Geological objections to
Surrey County Council planning application no. 2018/0152
by
UK Oil & Gas for hydrocarbon developments at Horse Hill

David Smythe

21 June 2019

Fig. 3.4

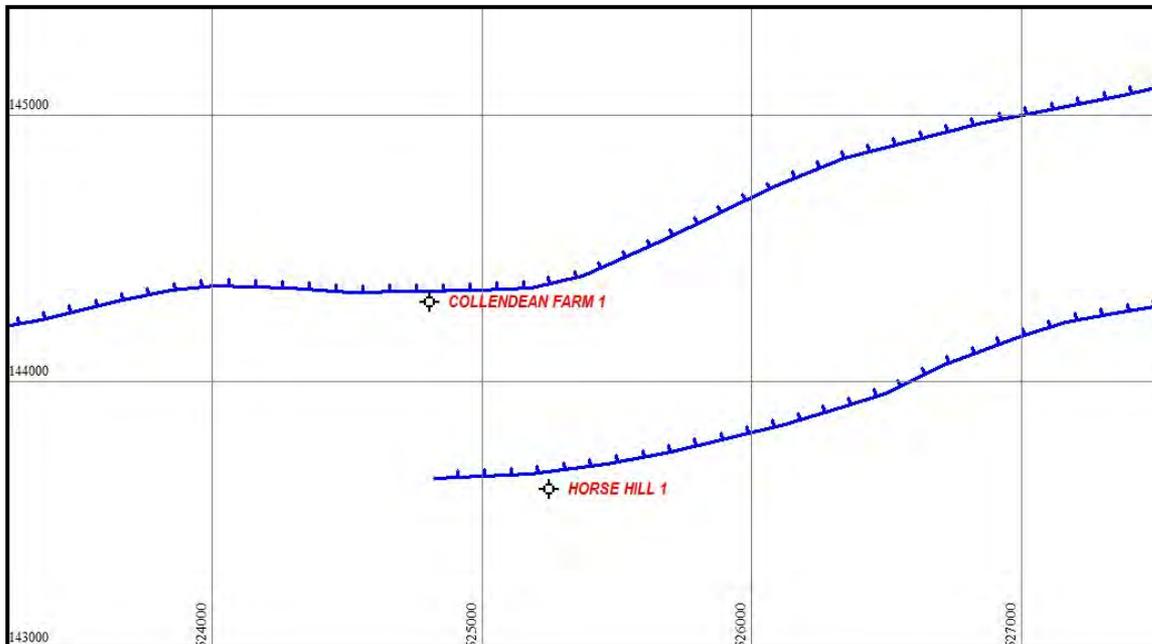
Figure 3.4 summarises the UKOG fault mapping (upper map) compared with my version (lower map). The UKOG version forces fault traces through even where the seismic data confirm a lack of faults with a discernible vertical offset. In contrast, my version honours the data, placing a fault only where seismic evidence exists for one.

UKOG fault interpretation. Fault changes sense of displacement (arrows)

DKS fault interpretation; there are two separate faults

Fig. 3.6

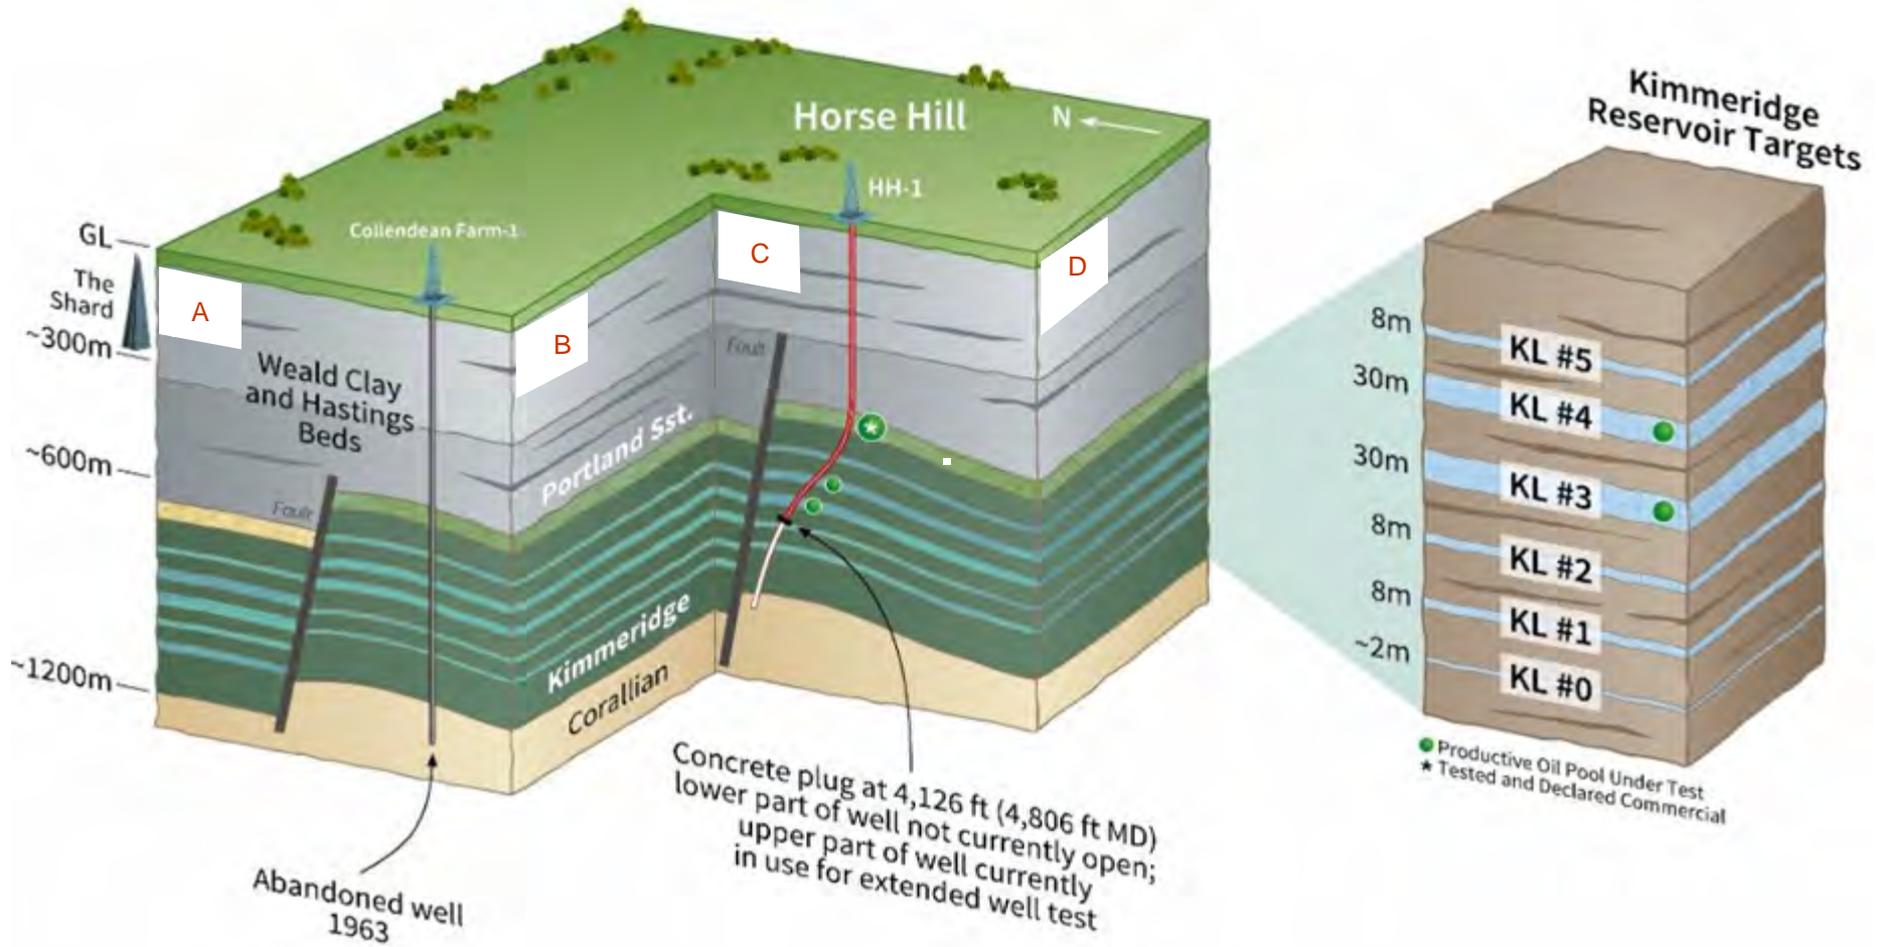
Instead of submitting the necessary detailed structural geology maps, UKOG sees fit to supply merely a couple of cartoon perspective views of the geology and the proposed development drilling. Figure 3.6 shows the first of these. It purports to be a perspective or isometric view of the geology, with the two existing wells shown in the N-S vertical faces here labelled A and C respectively. East-west face B shows no fault. Referring to Figure 3.7, this absence implies that there are two separate faults, conforming to my Collendean Farm and Horse Hill Faults, respectively. If the UKOG interpretation of the Top Portland Sandstone shown in Figure 3.3 is correct, there should be the single 'Horse Hill Fault' cutting face B. Note that both the faults in the cartoon of Figure 3.6 displace the Top Portland down to the north. So UKOG's maps and cartoons are internally inconsistent.

This cartoon implies two separate faults, because if there were only one fault it should intersect the south-facing vertical section B.

Fig. 3.7

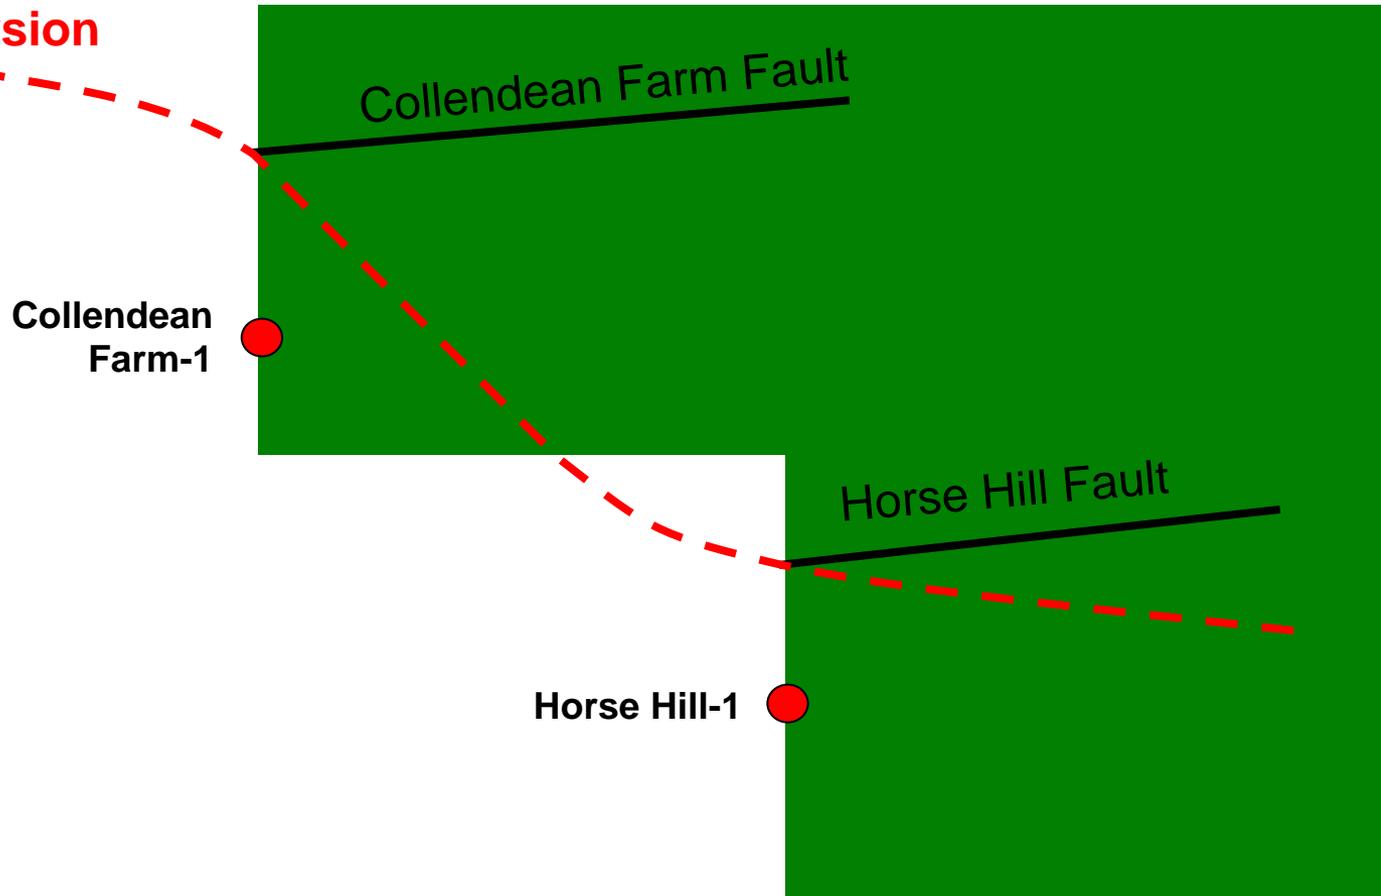
The location of CF-1 in relation to the major nearby fault is also internally inconsistent. In Figure 3.6 the well lies to the *south* of the major fault, but in the even more recent structural map of the deeper Great Oolite horizon (Fig. 2.1) the well is positioned by UKOG to the *north* of the major fault. If the correct location for CF-1 is taken into account, the vertical well intersects the fault at Top Great Oolite level.

Plan view of Figure 3.6, demonstrating that the previous UKOG single fault version is no longer current. Note also that CF-1 is now on the south side of the Collendean Farm Fault.

ES Figure 5: Proposed Development at Horse Hill Well Site¹²

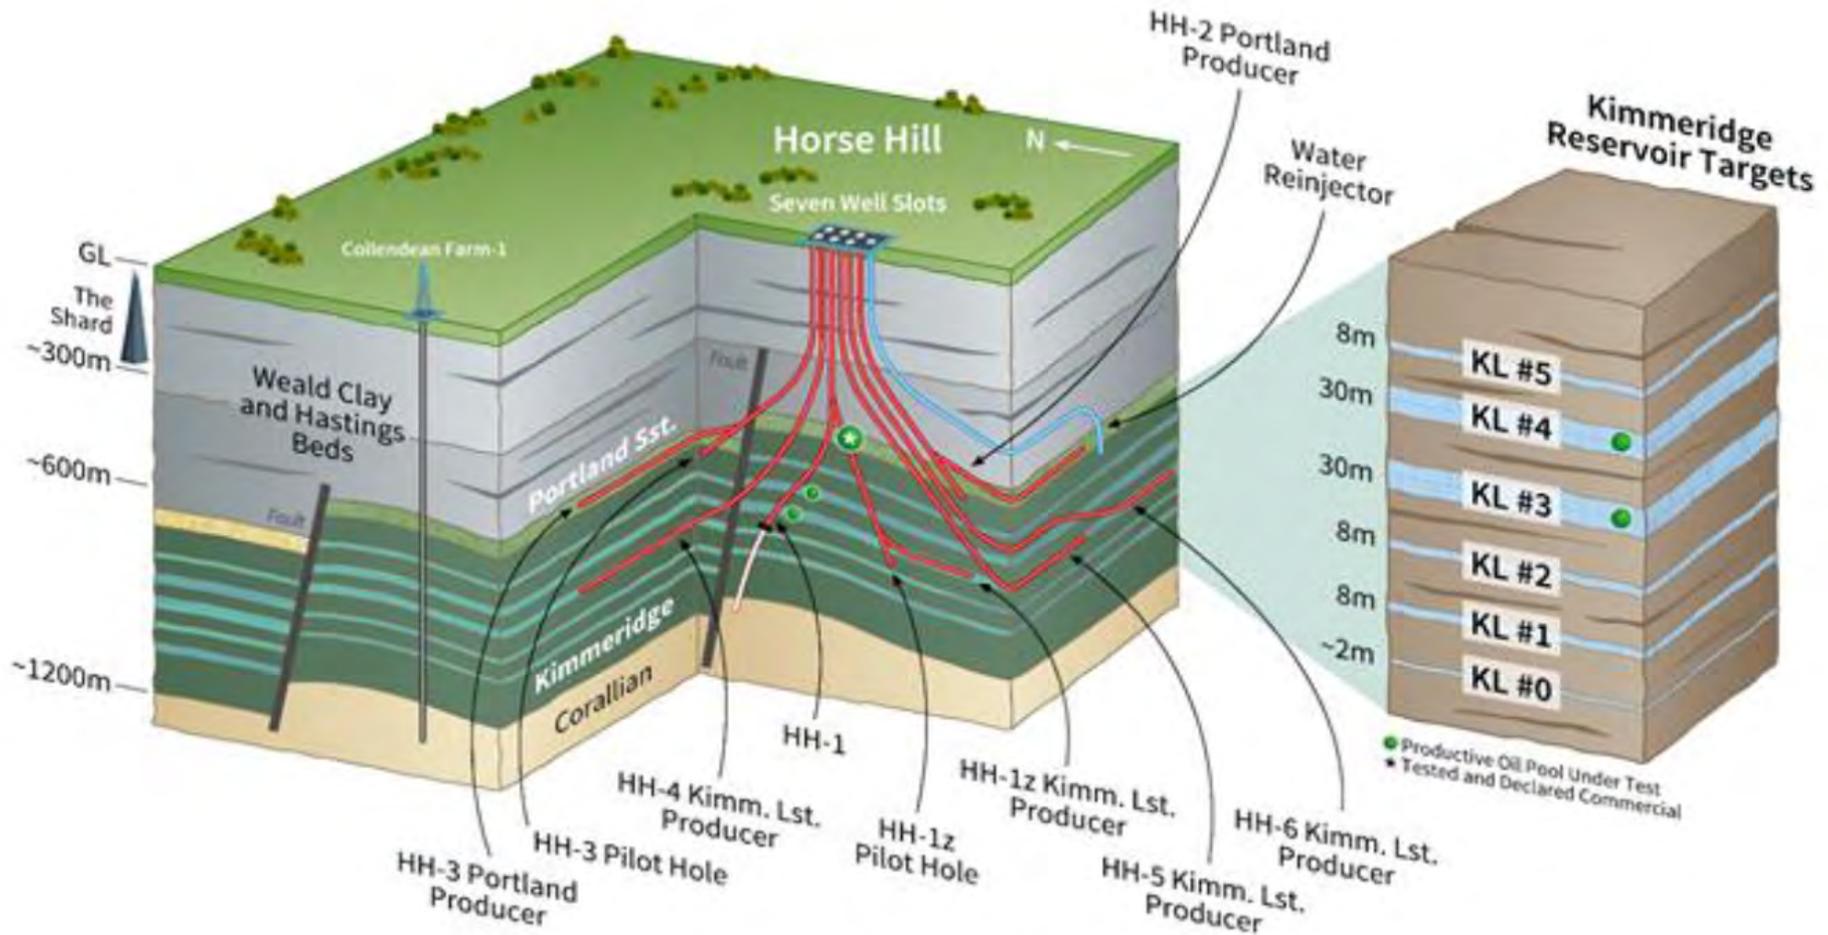
The second cartoon submitted by UKOG shows the proposed development (Figure 3.8). Note that the vertical faces of the 3D perspective view are aligned E-W or N-S. So the wells depicted on these faces deviate in the same two directions. But the more easterly of the two subsurface deviation sectors specified by UKOG (Figure 3.9) does not allow for wells from the wellpad to deviate initially southward, viz. HH-1z, HH-1z "producer" (which should be labelled more correctly as HH-1y), HH-5, HH-6, HH-2, and the "Water re-injector" well.

This cartoon grossly is insufficient in detail for a serious production planning application. But the required detail has not been submitted.

Fig. 3.9

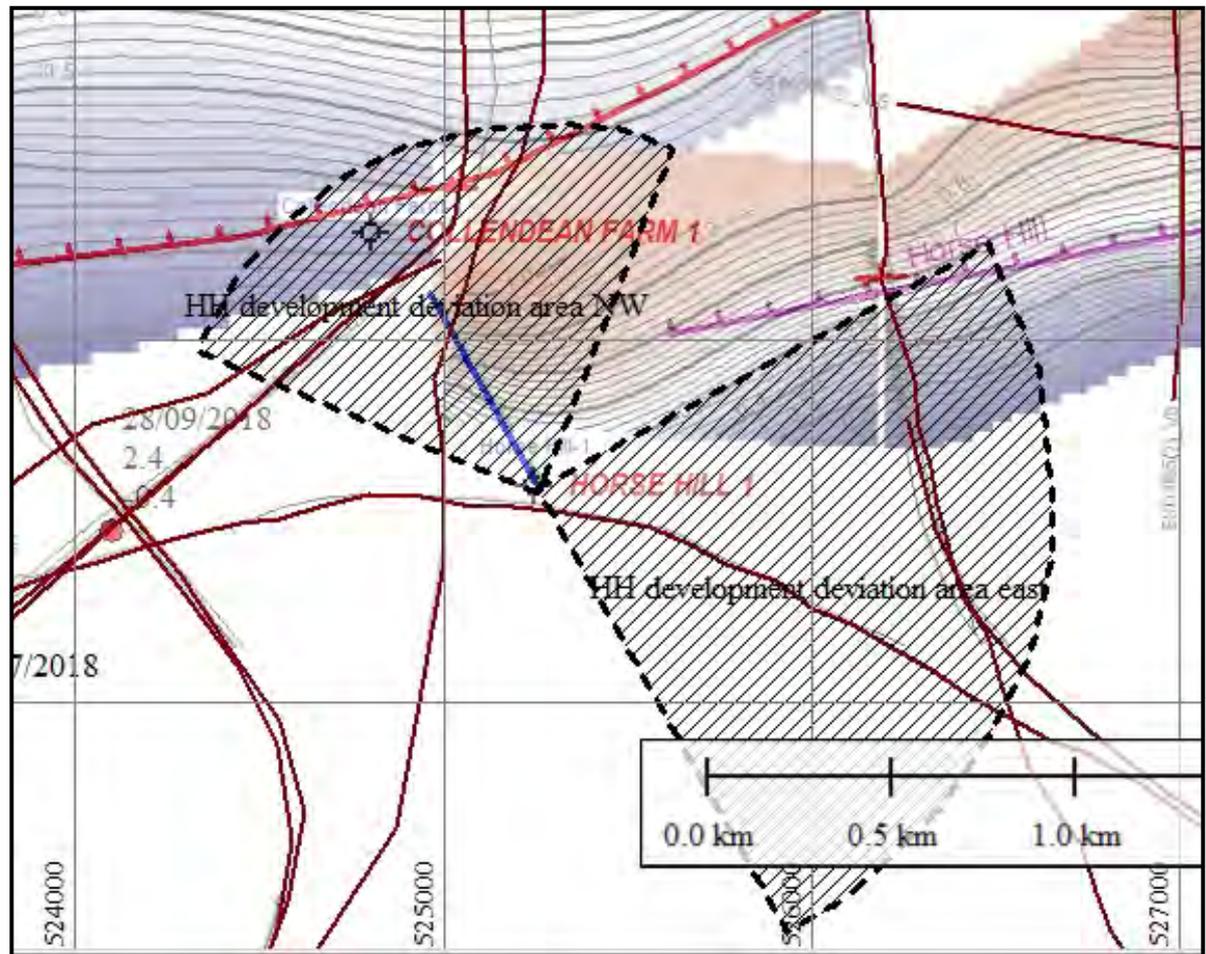
- Plans submitted are mere sketches.
- Wells have inadequate seismic (structural) control.
- Geology assumed flat, no faults.
- Wells deviating south go outside specified deviation sector.
- 3D seismic volume needed before drilling permitted.
- Geology needs to be re-interpreted from scratch.
- Learn from BB-1 fiasco.
- UKOG now claims neither fracking nor acidisation needed.

Fig. 6.1

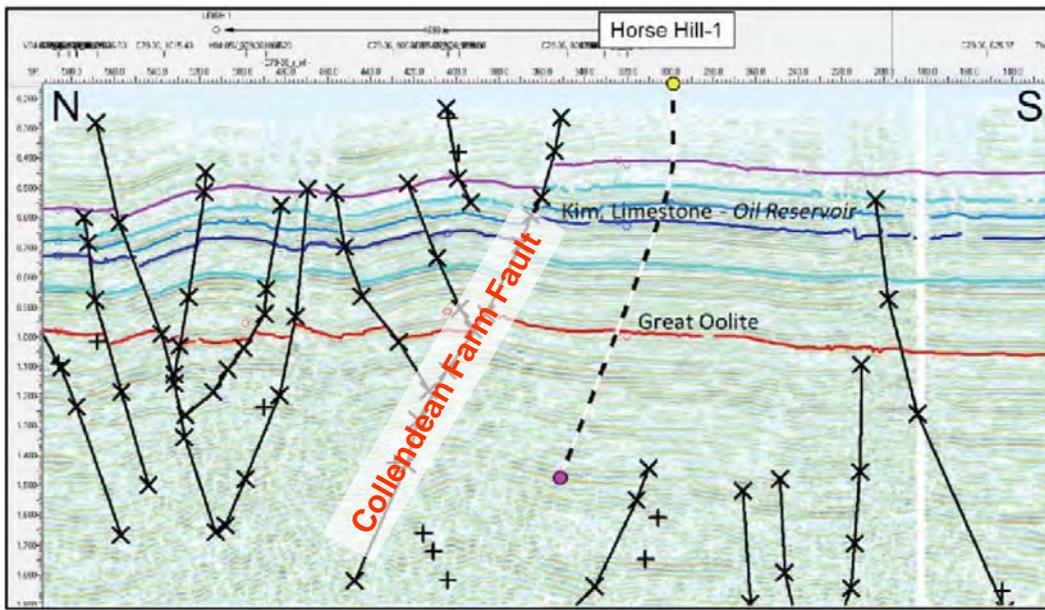
UKOG depicts part of an interpreted seismic line (its figure E) which I reproduce here in the upper part of Figure 6.1. The biggest fault in the centre of the section is evidently the Collendean Farm Fault, which I have labelled as such, although UKOG calls it the Horse Hill Fault. Note that the downthrow is to the north, which is correct. Contrast that with the downthrow to the south shown in Figure 3.3. The seismic section is a reprocessed and migrated version of C79-36. UKOG has projected onto this section the deviated HH-1 well from 1000 m to the ENE, stating in its figure D that "*the Horse Hill-1 well does not intersect a fault (see also Figure E)*". The map of the locality reproduced in the lower part of Figure 6.1 shows that this projection is spurious, in that UKOG has chosen a seismic line far away from the local complexity of the faulting in the area of the two wells.

UKOG interpretation of line C79-36 showing the Collendean Farm Fault and other faults. HH-1 has been projected WSW by 1000 m (black-and-white dashed line).
